MATERIALS LICENSE

Amendment No. 02

1. TGM Detectors, Inc.

In response to your telephone call last week regarding TGM Detectors' license renewal application number 20-14079-02 (Control No. 114561), TGM has prepared a response to your following verbal questions:

Diagram 1 : GM tube and smear geometry.

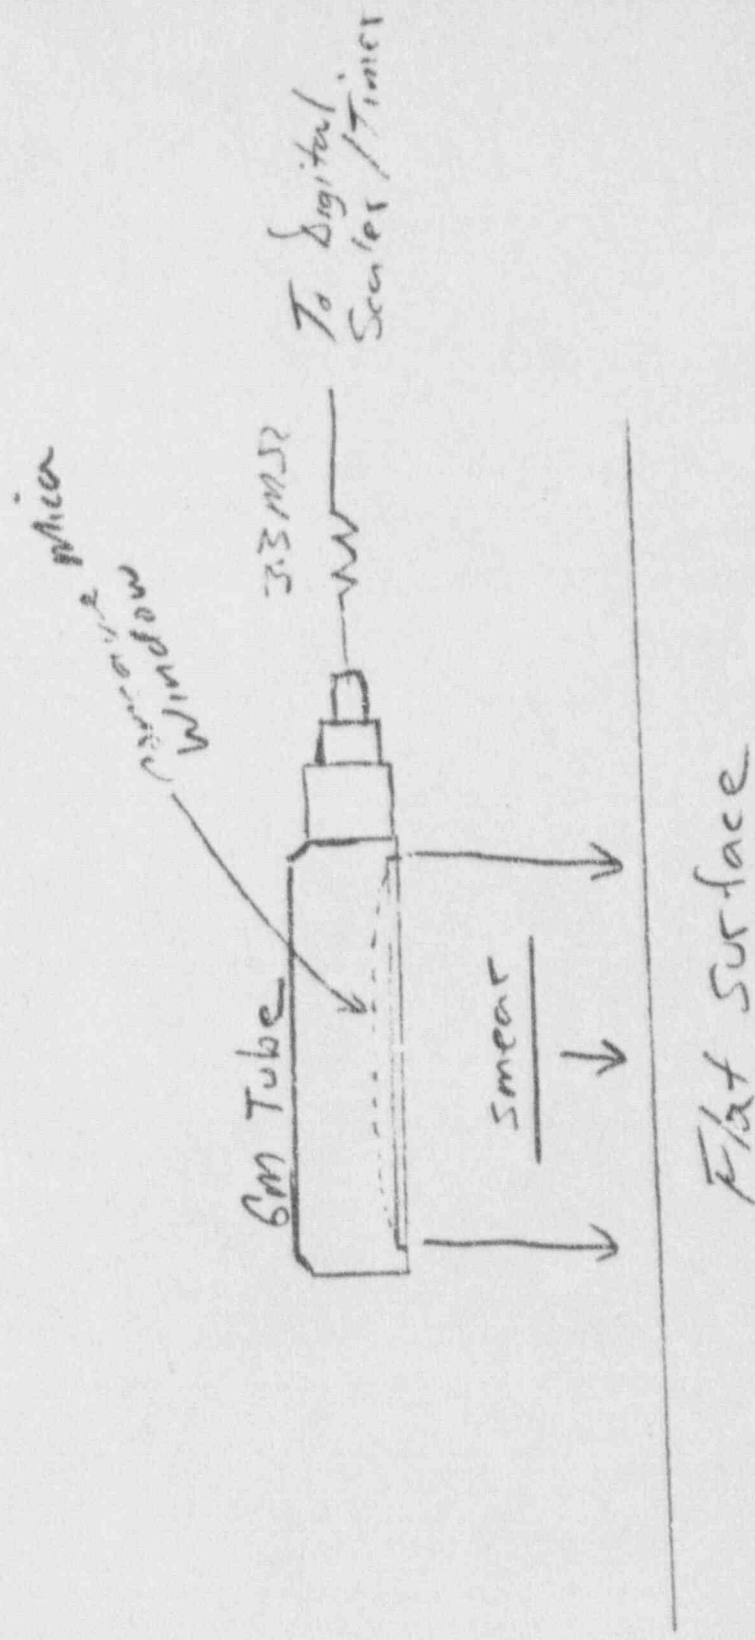
1. What type of wipe do we use for leak testing our sealed sources?
2. What surfaces will be wiped on the sealed sources.
3. What is the total counting time used in our MDA equation.
4. Provide a diagram of the geometry of the pancake GM tube and the wipe being sampled.
5. Do we calibrate our radiation survey meters in-house?

Question #4: The smear is placed on a flat surface and the GM tube is placed directly over it (also resting on the flat surface) such that the Mica window is "looking" at the smear. Distance between the GM tube's concave window and the smear is less than 4 millimeters. Diagram attached.

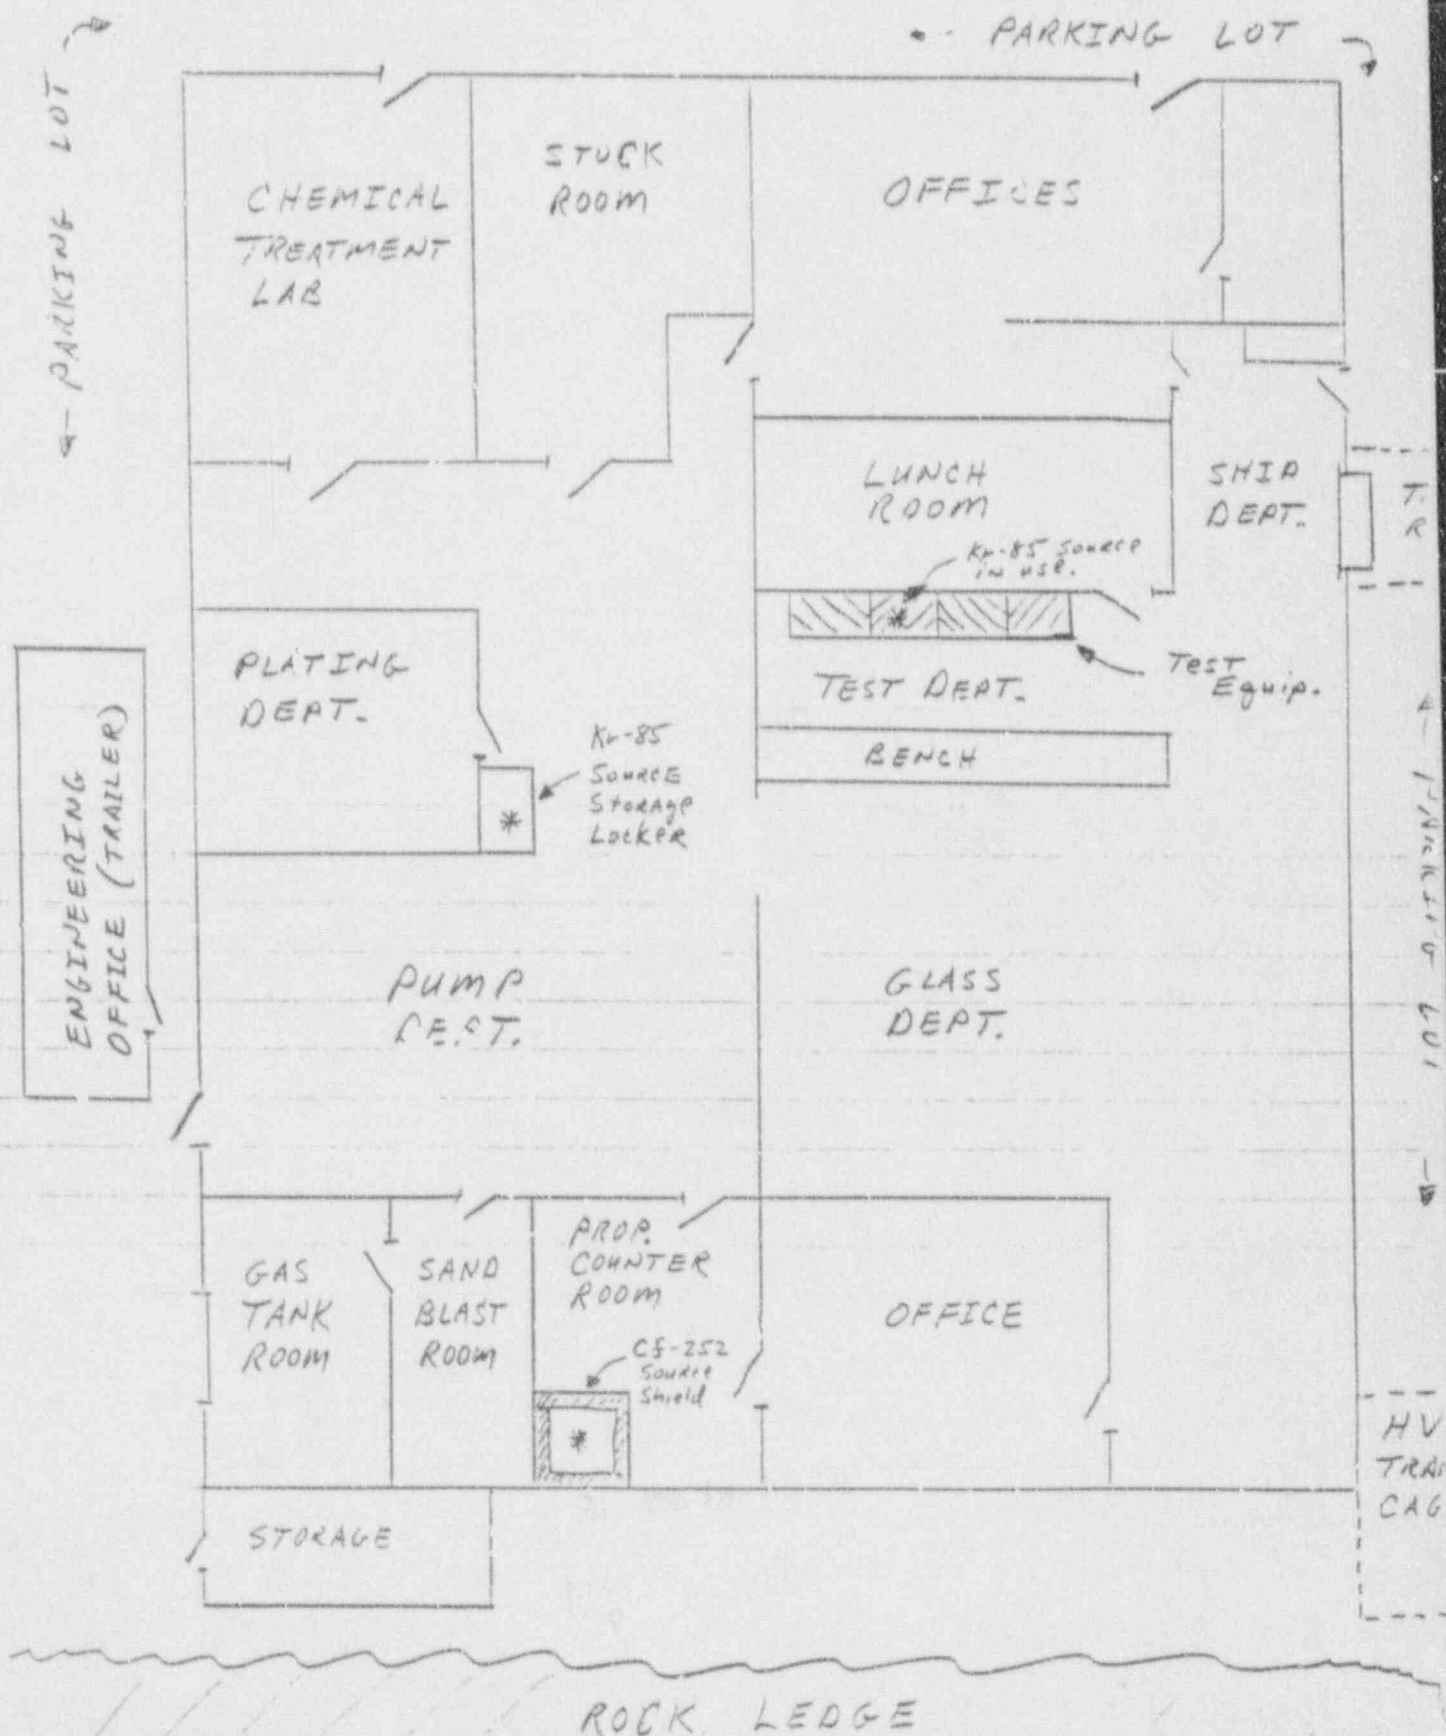
1. Please specify the permanent location of the J. L. Shepard irradiator. Please include a diagram of the room and adjacent areas. The diagram may be hand drawn. Please state any other use(s) of the room and the adjacent areas, if any.

Refer to attached facility sketch. The Krypton-85 source is contained within the original General Nucleonics shielded gauge style housing. Maximum exposure rate from the bottom of the device is 10 mR/hr. It is stored in a locker with pad lock, and is used in the test department for evaluating GM tube characteristics. Surveys around test equipment show minimal exposure levels while in use.
